ITEM #: 6.13	COMMITTEE OF ADJUSTMENT REPORT MINOR VARIANCE APPLICATION A220/22 365 Firglen Ridge, Woodbridge
---------------------	--

**COMMITTEE OF ADJUSTMENT REPORT
MINOR VARIANCE APPLICATION
A220/22
365 Firglen Rdg Woodbridge ON**

ITEM NUMBER: 6.13	CITY WARD #: 2
APPLICANT:	Vita Diserio
AGENT:	Michael Persechini
PROPERTY:	365 Firglen Rdg Woodbridge ON
ZONING DESIGNATION:	See Below
VAUGHAN OFFICIAL PLAN (2010) DESIGNATION:	Vaughan Official Plan 2010 ('VOP 2010'): "Low-Rise Residential", Volume 2, Section 11.11 Woodbridge Centre Secondary Plan
RELATED DEVELOPMENT APPLICATIONS:	None
PURPOSE OF APPLICATION:	Relief from the Zoning By-law is being requested to permit the construction of a proposed pool house and existing landscaping in the rear yard.

SITE PLAN

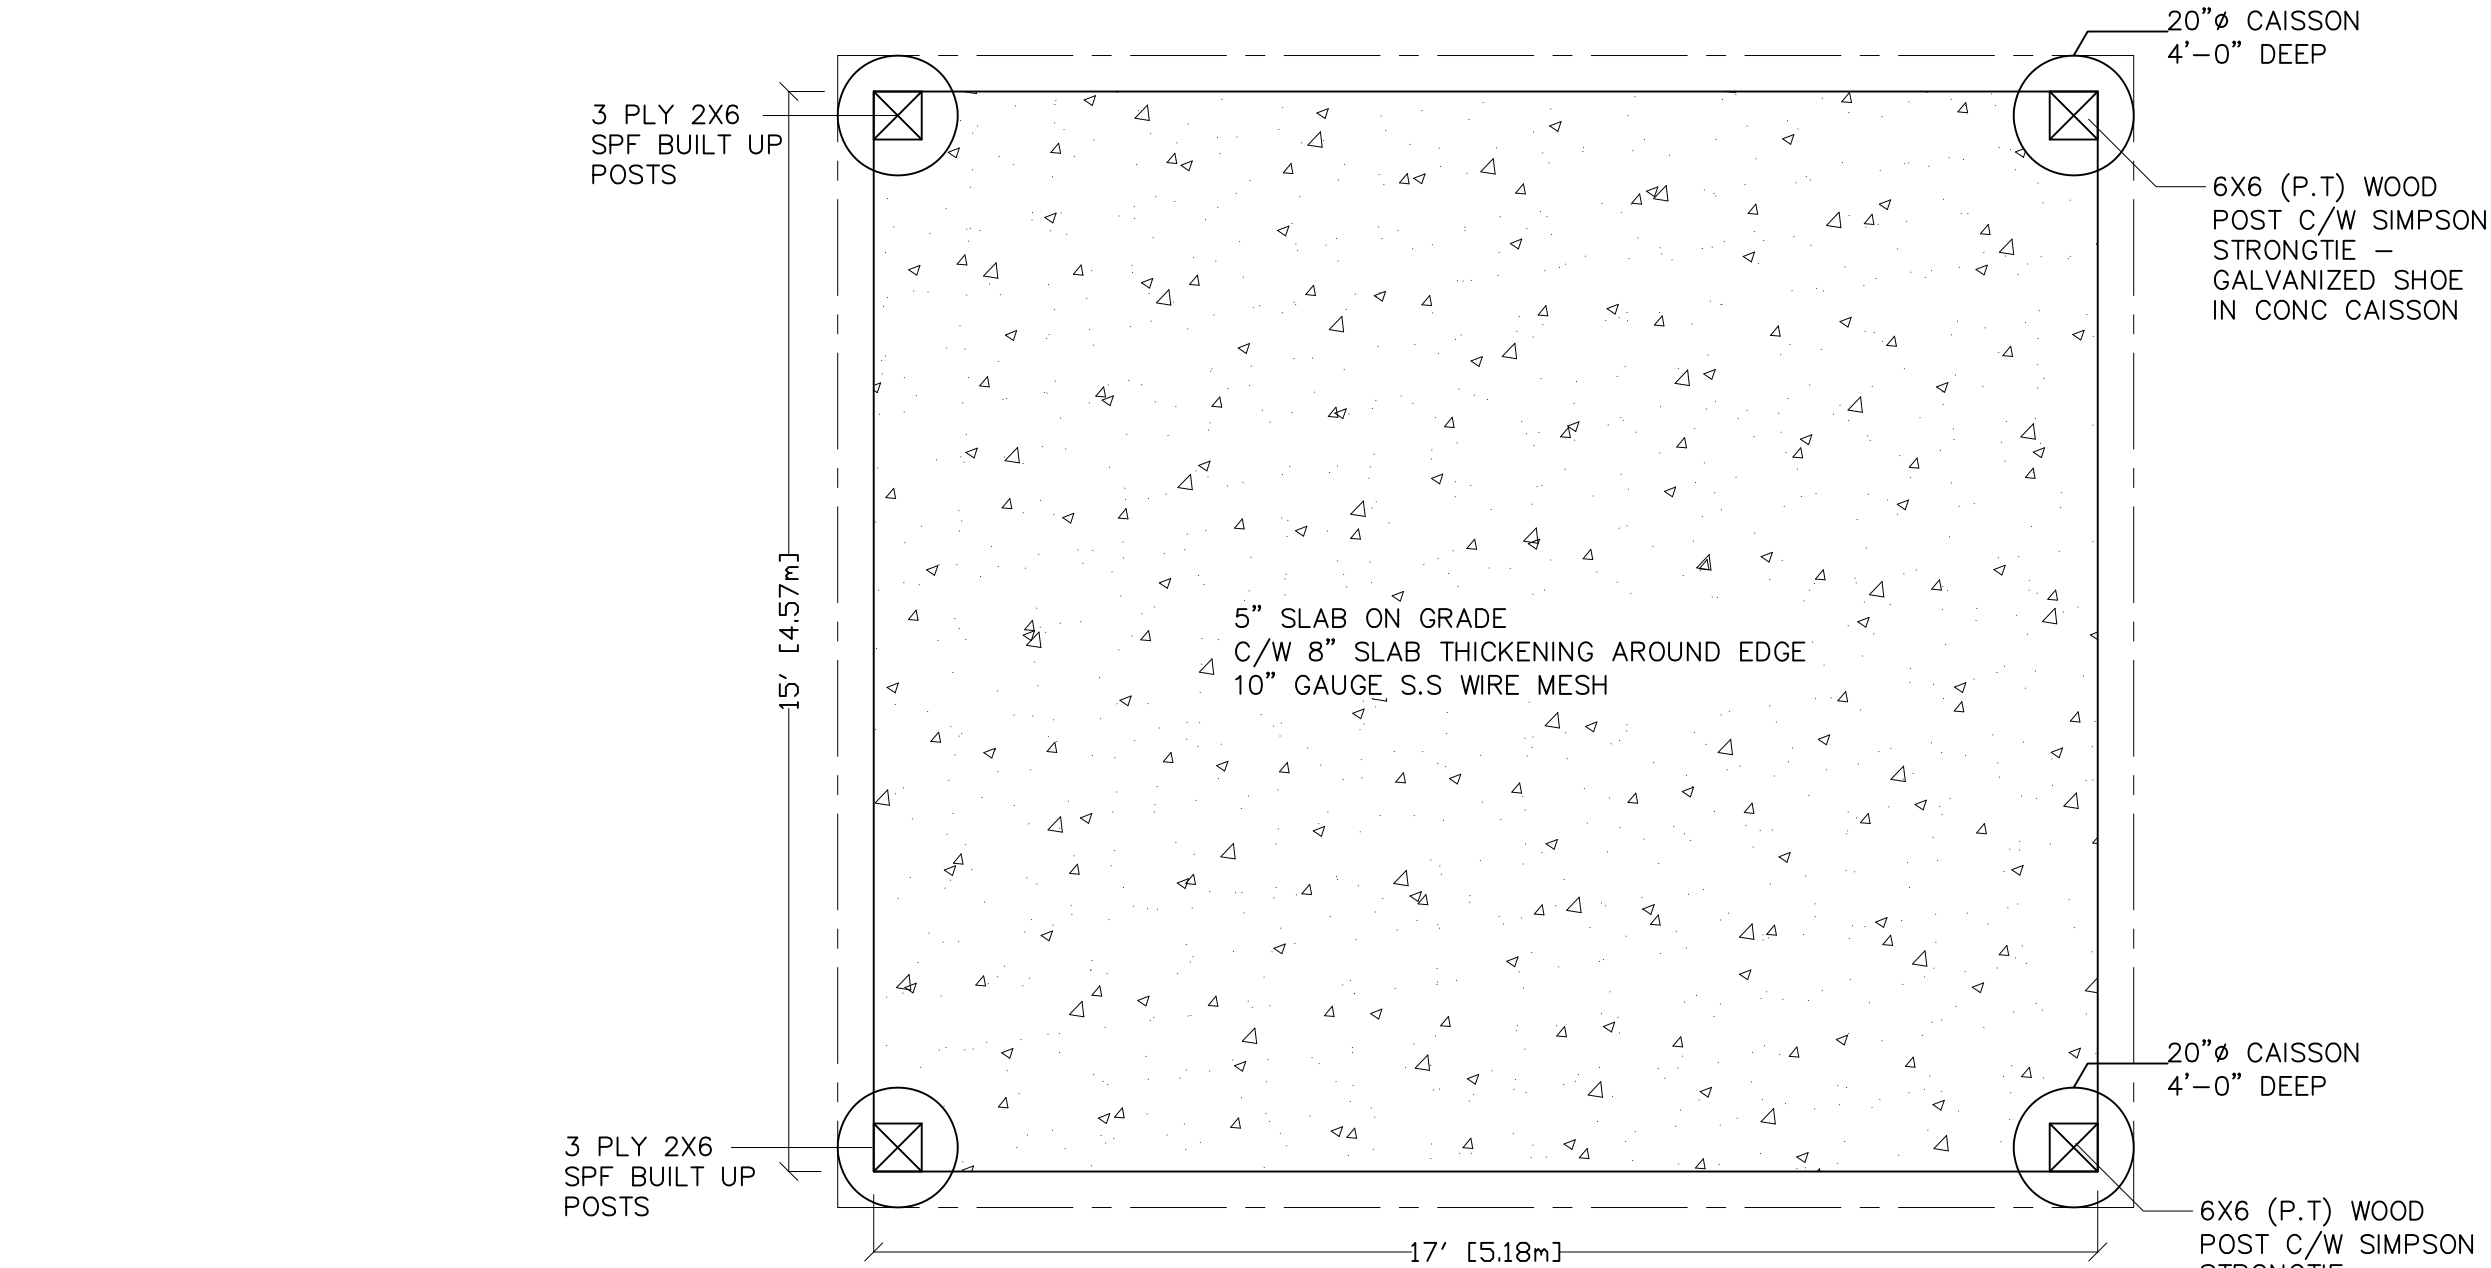
The Development Planning Department has no objection to Variances 1, 4 and 5 for the proposed pool house. The reduction to the rear and interior side yard setbacks for the pool house do not have adverse impacts to the neighbouring properties and an appropriate area for maintenance access is maintained. The pool house complies with all height requirements under both Zoning By-laws. The proposed rear yard setback also complies Zoning By-law 001-2021, which was enacted by Vaughan Council on October 20, 2021, but has been appealed to the Ontario Land Tribunal and is not in-effect.

The existing dwelling and proposed pool house have lot coverages of 29.45% and 2.54% respectively. The 1.99% increase to the lot coverage is minor in nature and is solely comprised of the pool house. As such, the Development Planning Department has no objection to Variances 2 and 6 for the increase in lot coverage.

The Development Planning Department is not in position to support Variances 3 and 7 for the reduced rear yard soft landscaping. The intent of the By-laws is to limit the amount of hardscaping on residential lots to maintain a balance between hardscaping and soft landscaping. Some of the functions of maintaining sufficient soft landscaped

Accordingly, the Development Planning Department cannot support Variances 3 and 7 and is of the opinion that the proposal is not minor in nature, does not maintain the general intent and purpose of the Zoning By-laws, and is not desirable for the appropriate development of the land.

The Development Planning Department recommends **refusal** of Variances 3 and 7, as they are not minor in nature, desirable or appropriate for the use of the land, and not in keeping with the intent of the Zoning By-laws.

The Development Planning Department recommends **approval** of Variances 1, 2, 4, 5 and 6.
